Service Bulletin

Bulletin No.: PI0829

Subject: Rattle/Buzz Type Noise at Center of Instrument Panel Area

Models: 2011-2012 Chevrolet Cruze
Built Prior to June 16, 2011

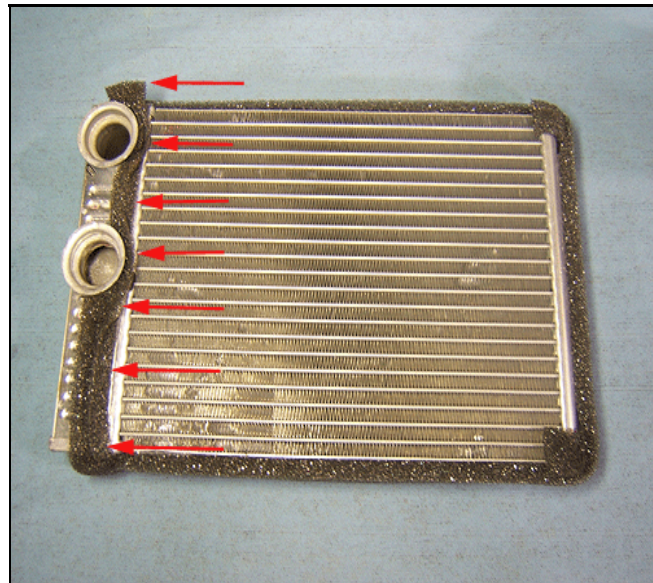
Some customers may comment on a rattle/buzz type noise from the center instrument panel area. This noise is most pronounced at engine speeds between 1500-2000 rpm and is more noticeable on vehicles equipped with manual transmissions. The noise may be mistaken for an underhood rattle due to its location.

This condition may be caused by contact between the heater core and the HVAC case.

2907493

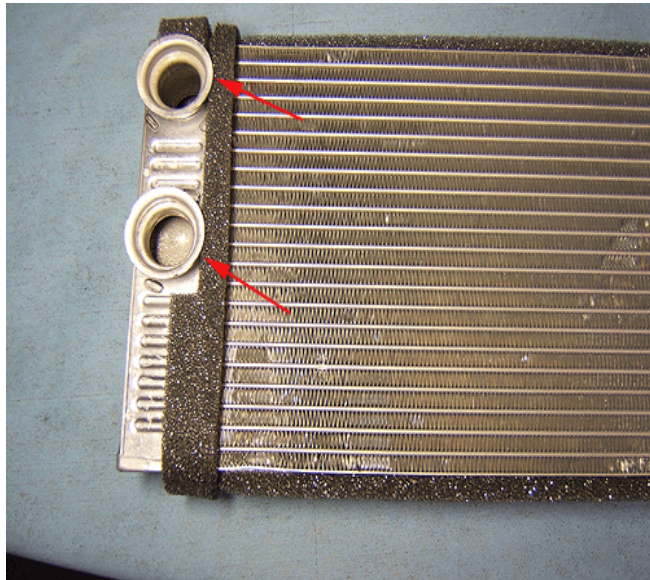
2. With the core on the bench, remove the foam seal on the tank end.

2907500

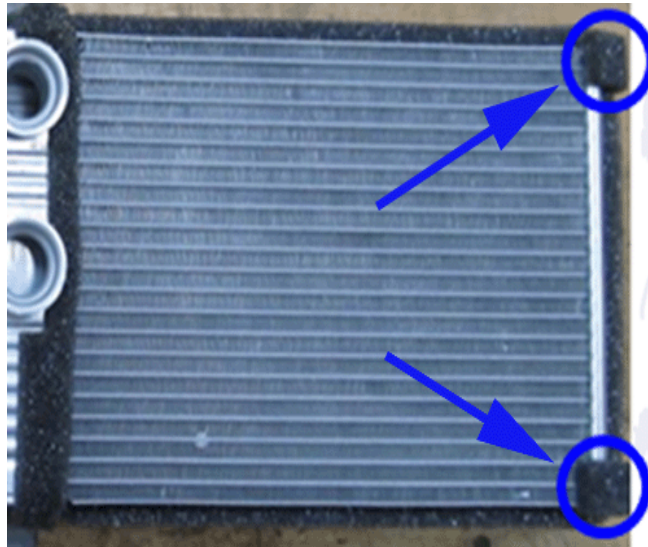
4. Wrap the foam seal around the tank end. Ensure the ends overlap as shown.
